SUBJECT: ST. LUCIE UNIT 2 - ISSUANCE OF AMENDMENT RE: BORIC ACID
MAKEUP SYSTEM (TAC NO. 69325)

AMENDMENT NO. 40 TO FACILITY OPERATING LICENSE NO. NPF-16 - ST. LUCIE, UNIT 2

SAFETY EVALUATION BY THE OFFICE OF NUCLEAR REACTOR REGULATION

ST. LUCIE PLANT, UNIT NO. 2

FIGURE 3.1-1 ST. LUCIE 2 MIN BAMT

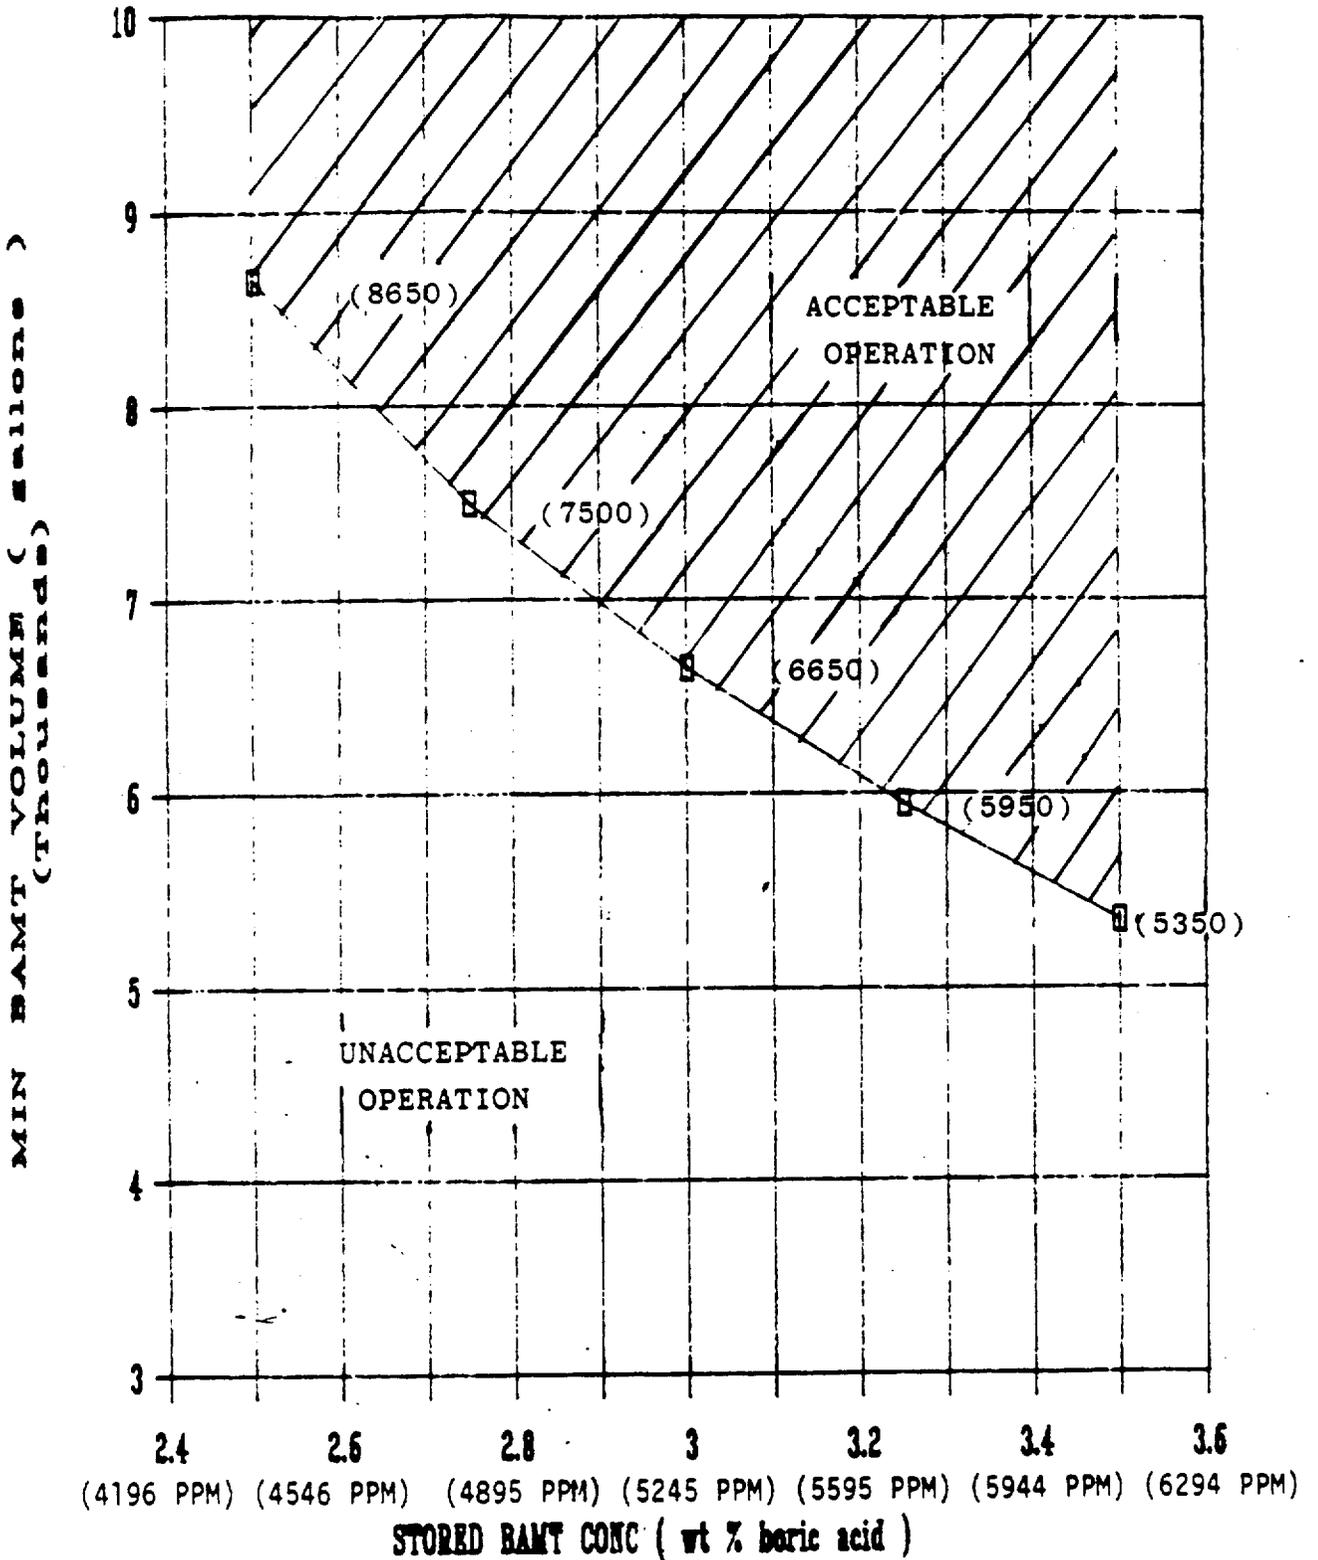
Figure 3.1-1 (for Operating Modes 1 through 4)

The existing figure specifies the minimum required BAMU water volume and temperature as a function of stored boric acid concentration for the various plant operating modes. The existing figure is applicable to either of the two BAMU tanks, each having a maximum capacity of 9,975 gallons. The revised figure specifies the minimum required water volume (contained in one or both BAMU tanks) as a function of boric acid concentration in the BAMU tank. This curve was generated in report CEN-365(L) for a minimum refueling water tank boron concentration of 1720 ppm boron. This curve conservatively bounds BAMU tank minimum required water volumes for conditions when the refueling water tank boron concentration is greater than 1720 ppm (a Technical Specification requirement). The range of boron concentration in the BAMU tank has been reduced from 8.0 to 12.0 weight percent boric acid to 2.5 to 3.5 weight percent. The

upper range of the required borated water volume has been increased from 6,520 gallons (8 weight percent) to 8,650 gallons (2.5 weight percent). The lower range of the required borated water volume has been decreased from 6,140 gallons (12 weight percent) to 5,350 gallons (3.5 weight percent). The revised Figure 3.1-1 is consistent with the analytical results of CEN-365(L) for plant conditions at Operating Modes 1 through 4 to maintain the required safe shutdown margin. The temperature versus BMT concentration curve has been removed from the Technical Specifications since it is no longer required. The revised figure is acceptable.

The existing Figure 3.1-1 specifies the volume of boric acid of 6,520 gallons at a minimum concentration of 8.0 weight percent to be maintained in the BAMU tank. The proposed changes provide a new range of boric acid concentration of 2.5 to 3.5 weight percent for one or both of the BAMU tanks. The revised volumes of Figure 3.1-1 lower the minimum water volume to 5,350 gallons. Deletion of the requirement to heat trace the BAMU system is consistent with the ability to maintain 2.5 to 3.5 weight percent boric acid in solution at temperatures above 50°F. The revised surveillance requirements delete verifying the BAMU tank temperature unless the auxiliary building temperature is below 55°F. For conservatism, this verification of temperature is done more frequently (24 hours versus 7 days) and the old surveillance requirement has been deleted.
